SUNDRY NOTICES AND REPORTS ON WELLS
*Do not use this form for proposals to drill or to re-enter an
abandoned well. Use form 3160-3 (APD) for such proposals.*

8. Well Name and No
Vega 9 Federal No. 1

2. Name of Operator
Cimarex Energy Co. of Colorado

BOP Changes

Exhibit E-1 -- Surface Casing BOP & Choke
Vega 9 Federal No. 1
 Cimarex Energy Co. of Colorado
 9-175-30E
 2310' FNL & 660' FEL
 Eddy County, NM

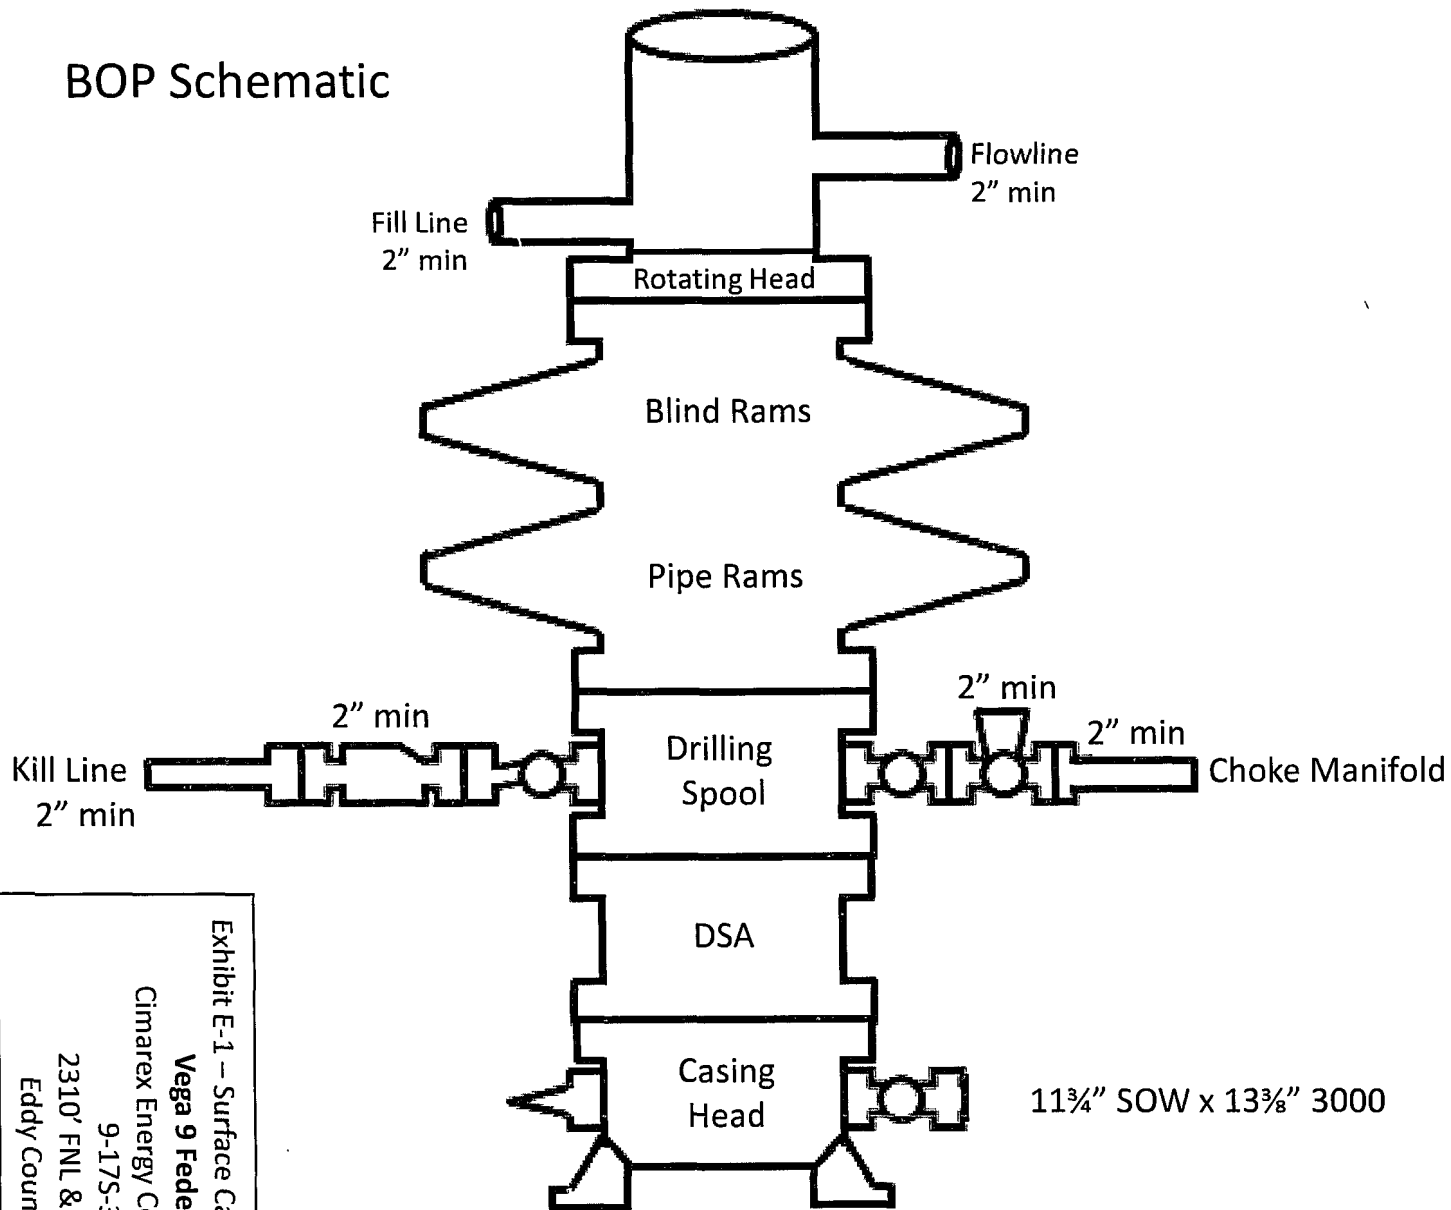
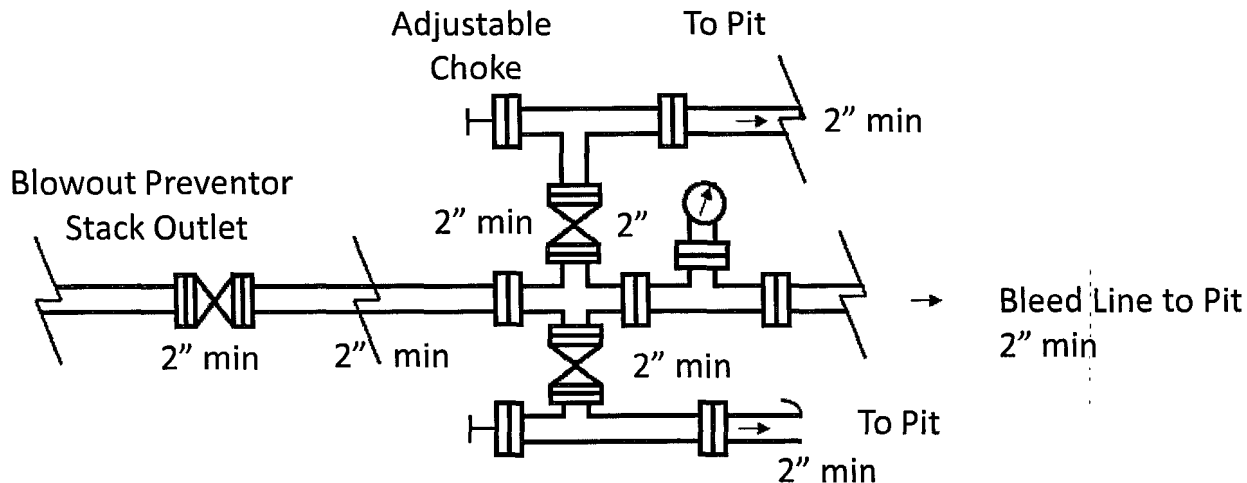
Cimarex is changing to a 2M BOP system.

Exhibit "E-1" - Surface Casing - An 11 $\frac{3}{4}$ " 2000 PSI working pressure B.O.P. consisting of one set of blind rams and one set of pipe rams. A choke manifold and 120 gallon accumulator with floor and remote operating stations and auxiliary power system. A kelly cock will be installed and maintained in operable condition and a drill string safety valve in the open position will be available on the rig floor. Ram-type BOP to be function-tested once per day. Ram-type preventor will be tested to 250 psi low and 2000 psi high, by an independent service company.

Exhibit E-2 – Int & Prod Csg BOP & Choke

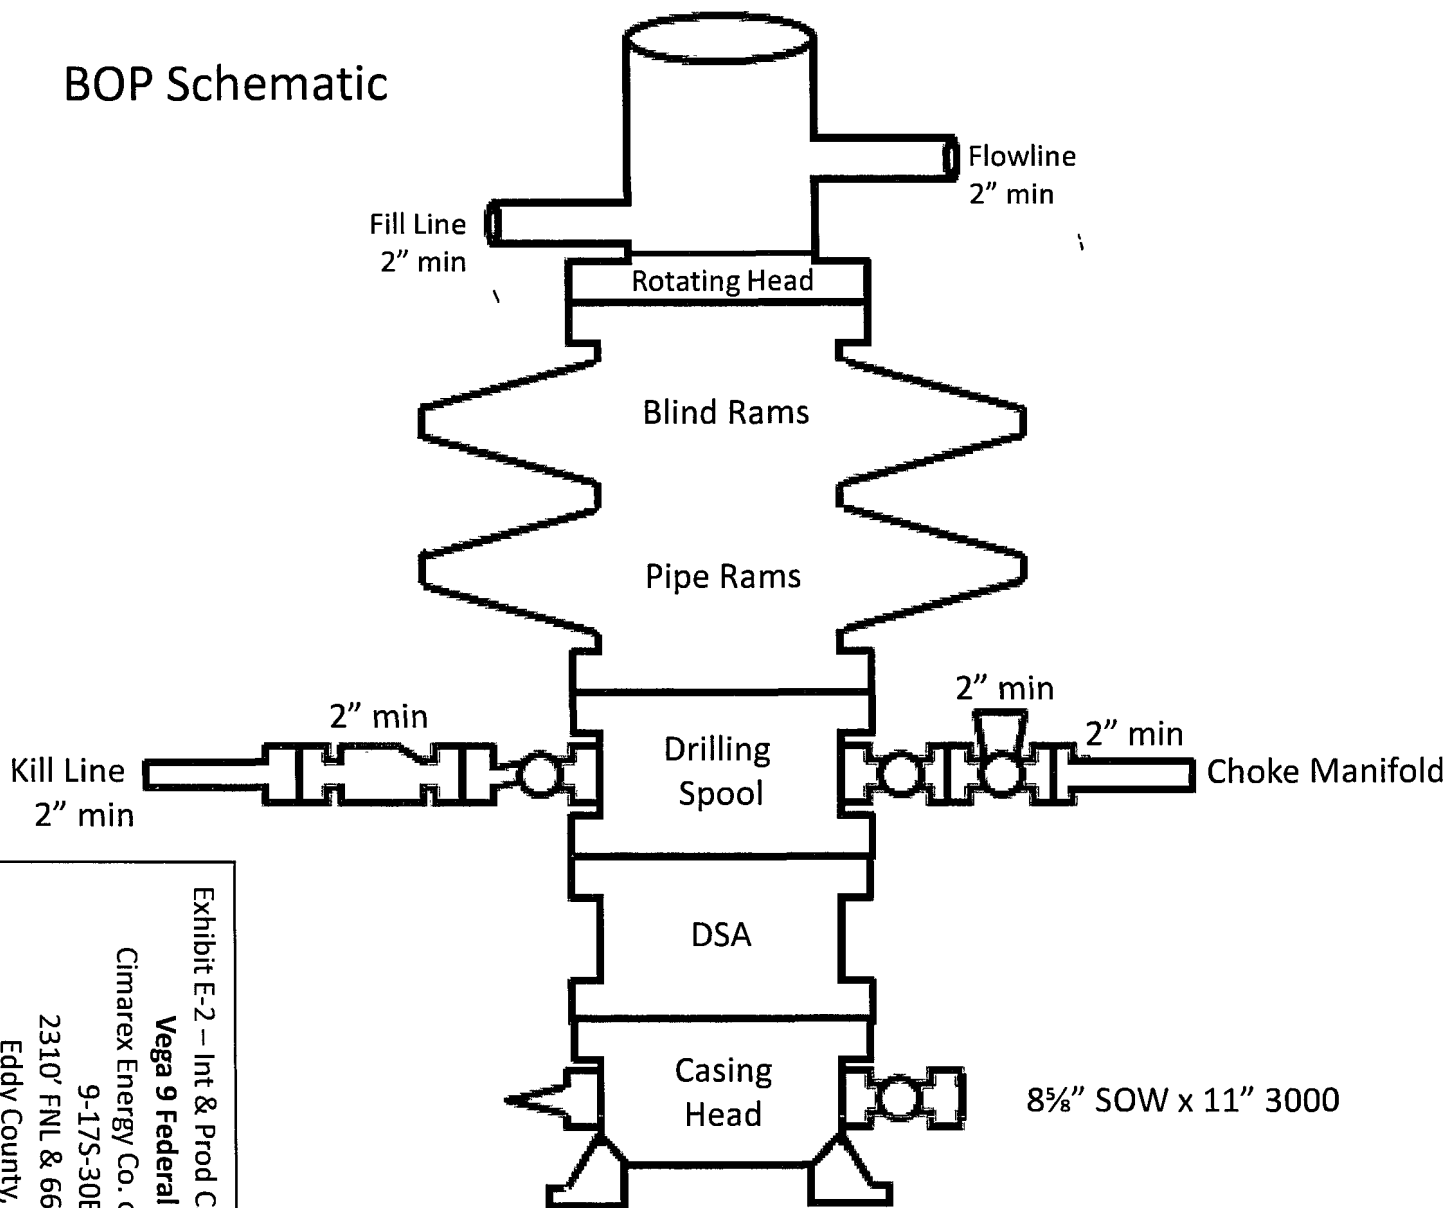
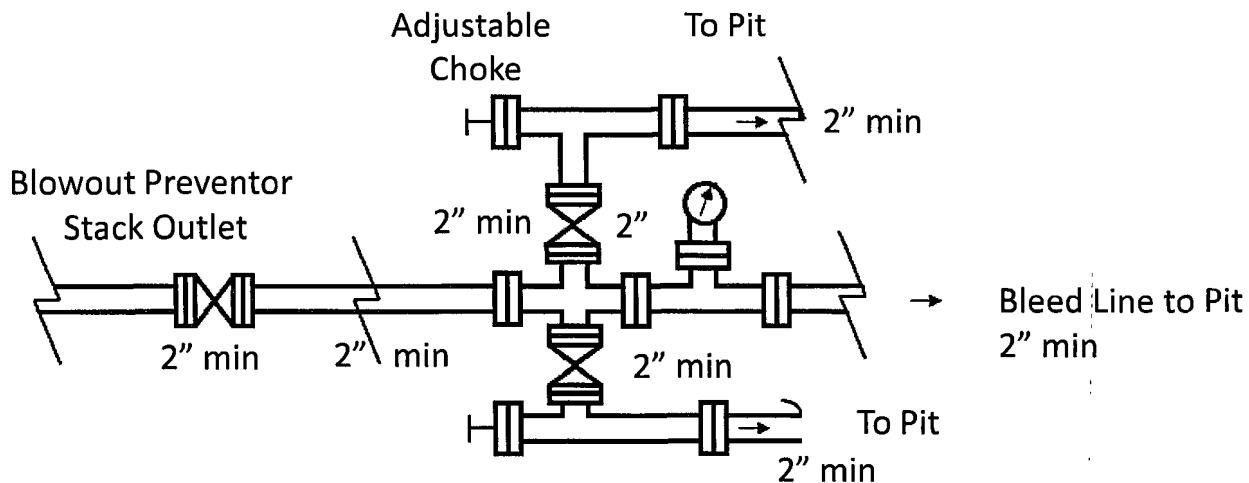
Exhibit "E-2" - Intermediate & Production Casing - An 8 $\frac{3}{4}$ " 2000 PSI working pressure B.O.P. consisting of one set of blind rams and one set of pipe rams. A choke manifold and 120 gallon accumulator with floor and remote operating stations and auxiliary power system. Rotating head below 1100'. A kelly cock will be installed and maintained in operable condition and a drill string safety valve in the open position will be available on the rig floor. Ram-type BOP to be tested to 250 psi low and 2000 psi high by an independent service company.

Exhibit D – Rig Diagram
Vega 9 Federal No. 1
 Cimarex Energy Co. of Colorado
 9-17S-30E
 2310' FNL & 660' FEL
 Eddy County, NM

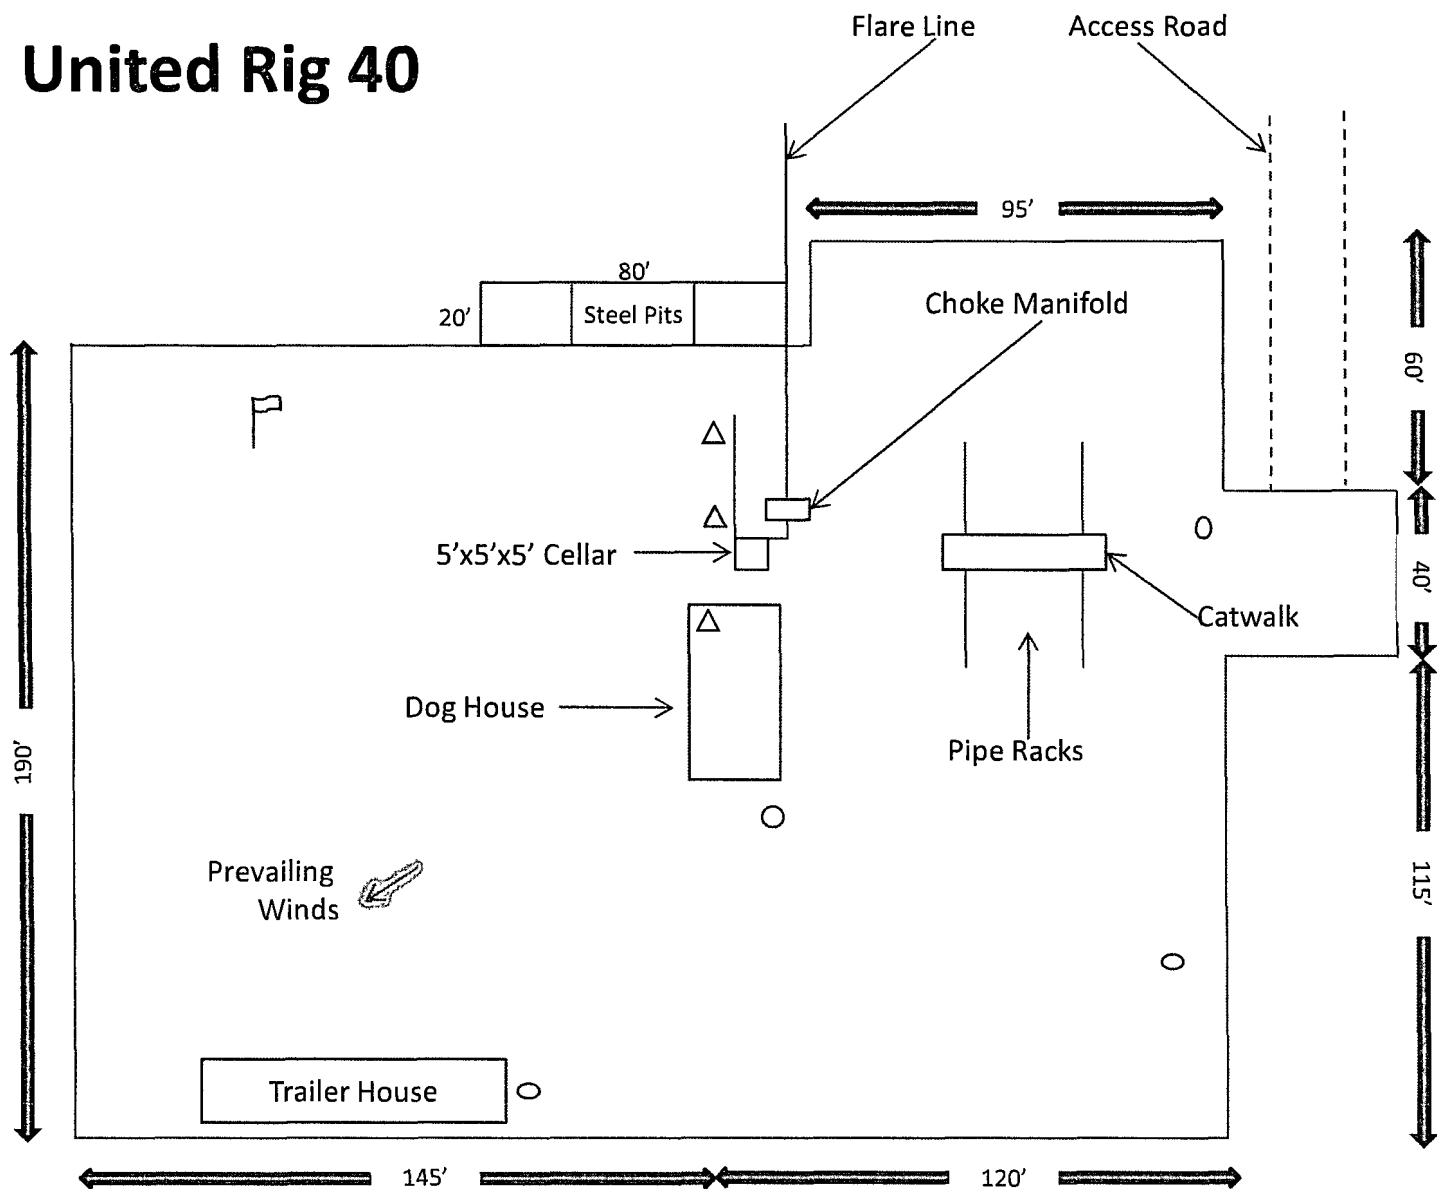
Cimarex is also switching to United Rig 40 and will be using a closed-loop mud circulating system.

- A. Exhibit "D" shows location and rig layout.
- C. Mud pits in the closed circulating system will be steel pits and the cuttings will be stored in steel containment pits.
- D. Cuttings will be stored in steel pits until they are hauled to a state-approved disposal facility.
- E. If the well is a producer, those areas of the location not essential to production facilities will be reclaimed and seeded per BLM requirements.
